Implications of the USGS analysis of slope stability at Sulphur Creek

Prepared for the National Marine Fisheries Service

Summary of comments and calculations

Figure 3. Calculated slope stability on units of THPs 413 and 307 in the absence of trees.

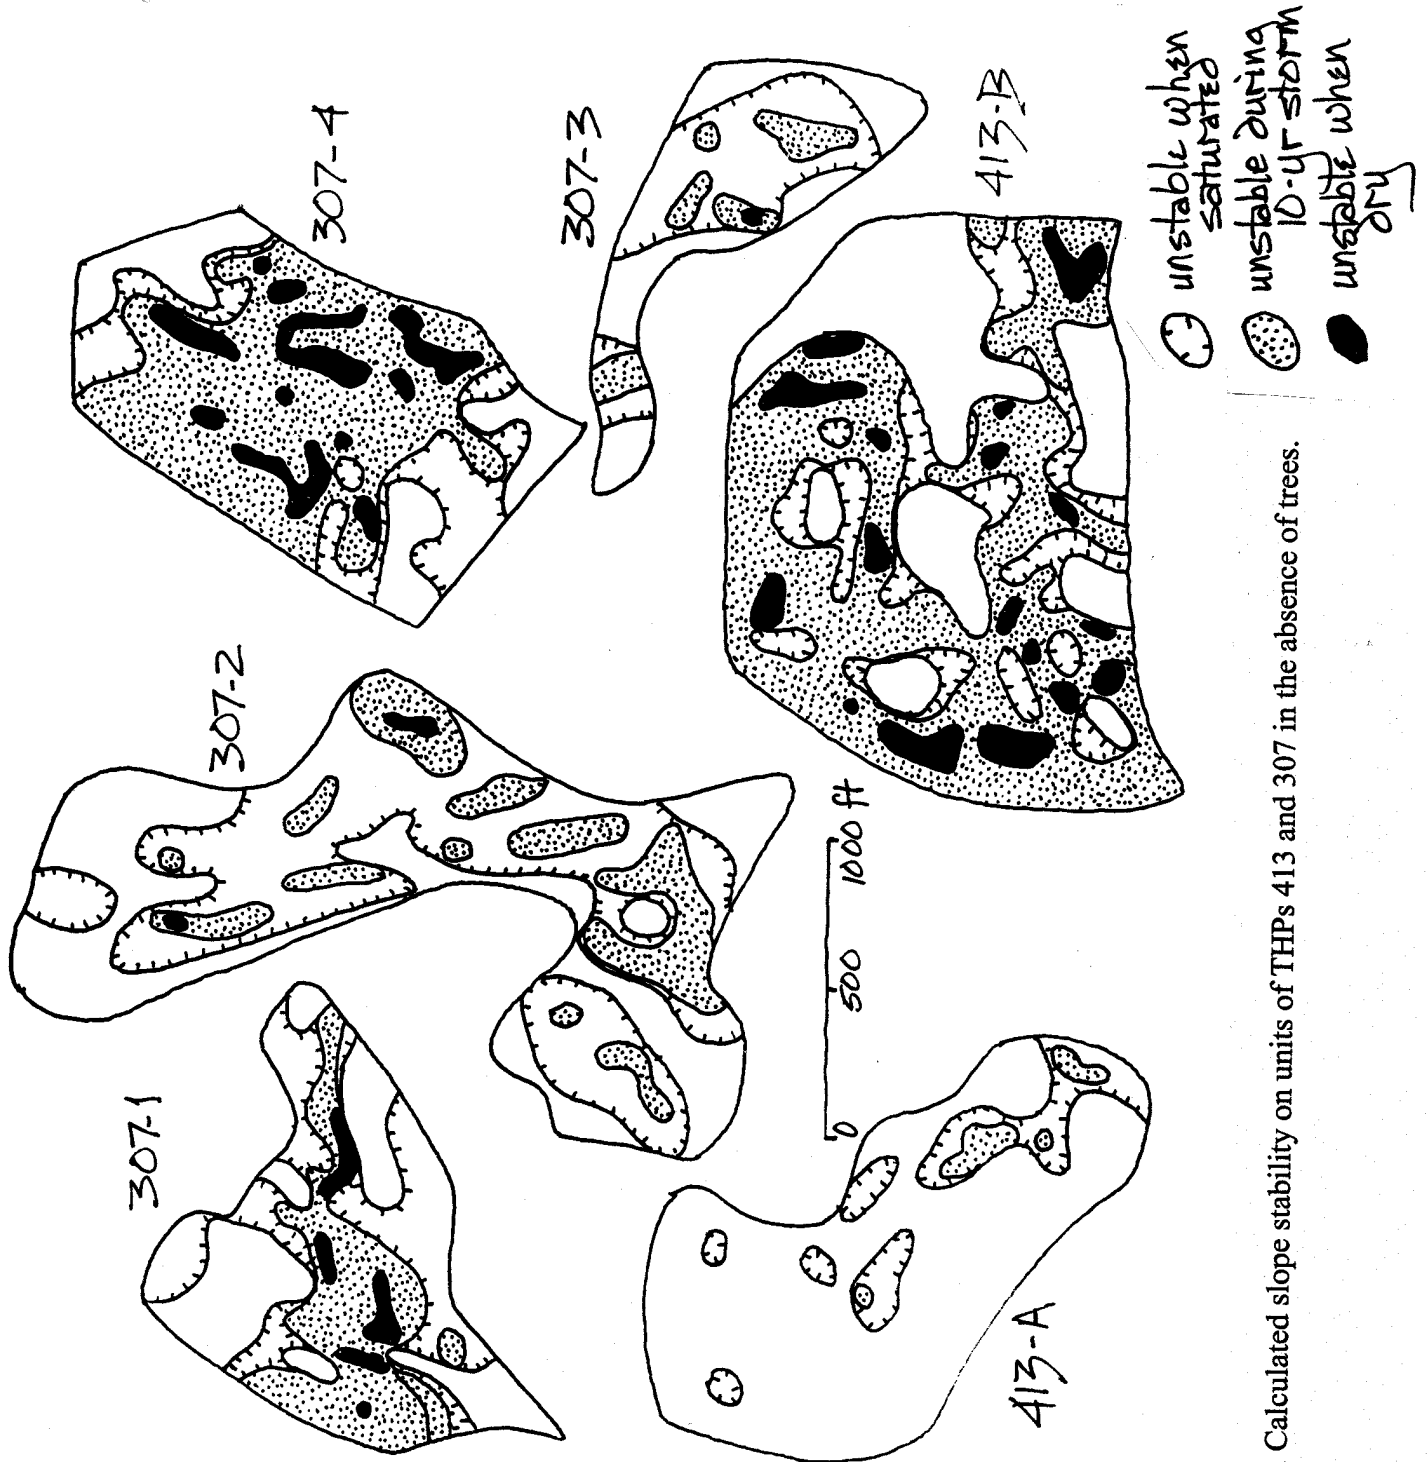
The distribution of slopes susceptible to failure in THPs 413 and 307 can be mapped using gradient information from USGS topographic quadrangles (Figure 3). The boundaries indicated reflect the areas susceptible to sliding during dry conditions, those susceptible at saturation, and those susceptible at water contents equivalent to the 10-year, 1-day rainfall at Kneeland. It is evident from the maps that a large proportion of the THP areas should be unstable under existing conditions if trees are not present. A landslide map provided with the engineering geologic report prepared by James Falls for THP 1-97-307 HUM indeed demonstrates that a high proportion of the unit surfaces have failed under current conditions.

Figure 5. Calculated slope stability on units of THPs 413 and 307 with trees present.

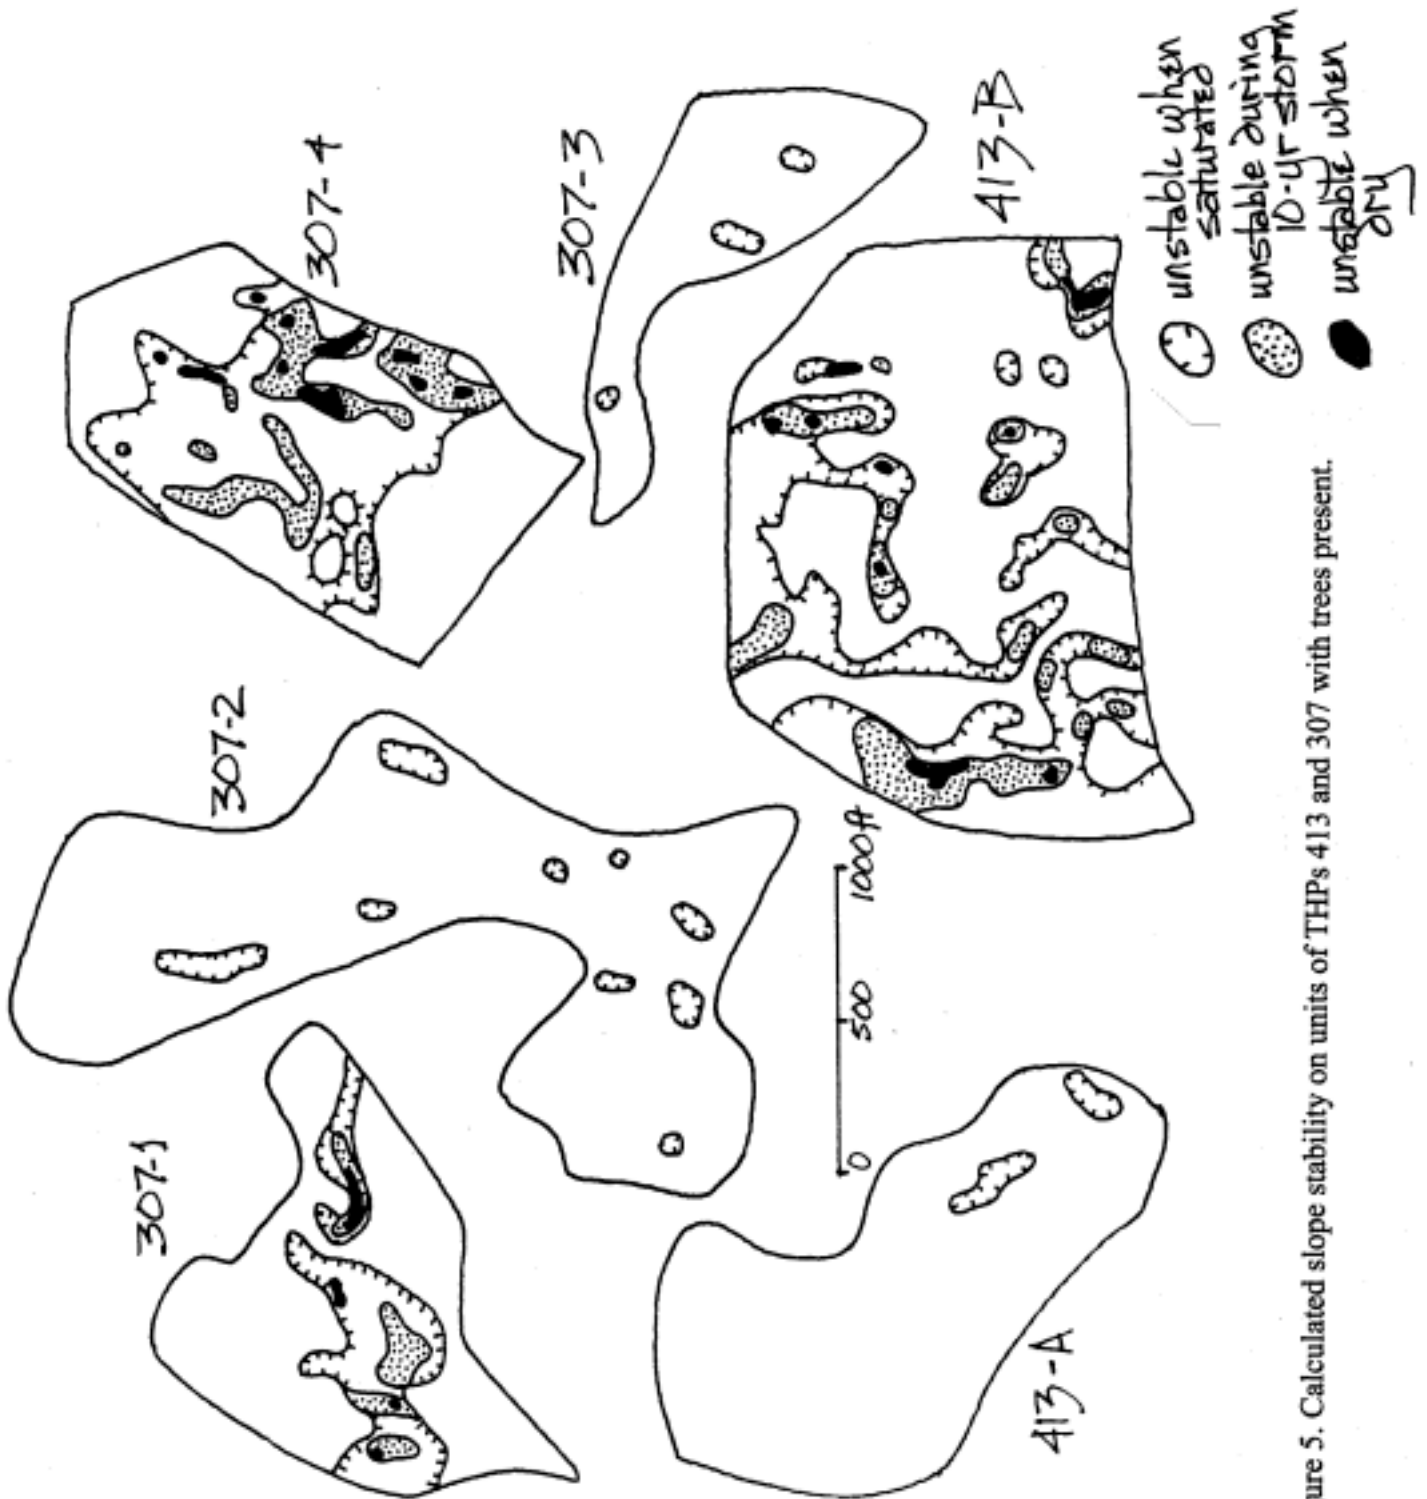
The locations of slopes that are potentially unstable even with trees present can now be mapped (Figure 5). For each unit, the difference in areas mapped as unstable between Figures 3 and 5 is an indication of the potential effects of logging on these slopes.
